Access Compliance Report

Public Rights-of-Way

Intersection ID: 43934	Main Street: ALBEMARLE_RD	Cross Street: CIRCUMFERENTIAL_RD	Location: SE
ADA ID: E2E4CAD0BEA3	Ramp Type: BlendTrans1	Initial Pass/Fail: Fail	Overall Compliance: No
		Severity Score: 10

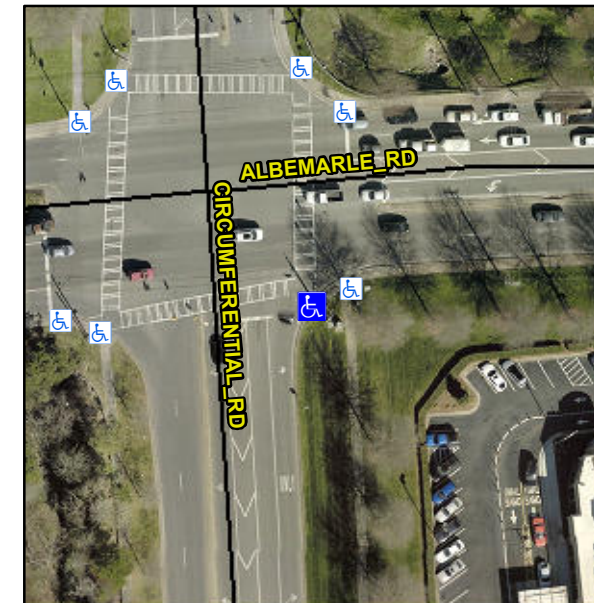
Not Found, R304.5.1, R304.5.3

Compliance	Description	Data	Compliance	Description	Data
N/A	Ramp Length (in)	62.0	Yes	BlendTrans Slope (%)	3.7
No	Ramp Width (in)	46.0	No	BlendTrans XSlope (%)	3.5
N/A	Flare Type LT	N/A	N/A	Flare Type RT	N/A
N/A	Flare Slope LT (%)	N/A	N/A	Flare Slope RT (%)	N/A
N/A	Flare Traversable LT?	N/A	N/A	Flare Traversable RT?	N/A
N/A	Landing Length (in)	N/A	N/A	DWS Provided?	N/A
N/A	Landing Width (in)	N/A	N/A	DWS Contrast?	N/A
N/A	Landing Slope (%)	N/A	N/A	DWS Length (in)	N/A
N/A	Landing X Slope (%)	N/A	N/A	DWS Full Width?	N/A
N/A	Landing Curb? (Y/N)	N/A	N/A	DWS Offset (in)	N/A
N/A	Shared Landing?	N/A			
N/A	Gutter Ponding?	N/A	N/A	Gutter Slope (%)	N/A
N/A	Gutter Lip Ht (in)	N/A	N/A	Gutter X Slope (%)	N/A
N/A	Painted X Walk1?	Yes	N/A	Painted X Walk2?	Yes
	X Walk 1 Direction	To N		X Walk 2 Direction	To W
	X Walk 1 Width (in)	115.0		X Walk 2 Width (in)	87.0
	X Walk 1 Slope (%)	5.1		X Walk 2 Slope (%)	1.9
	X Walk 1 X Slope (%)	1.4		X Walk 2 X Slope (%)	4.1

Remove & Replace Curb Ramp With Two New Directional Ramps or Equivalent.
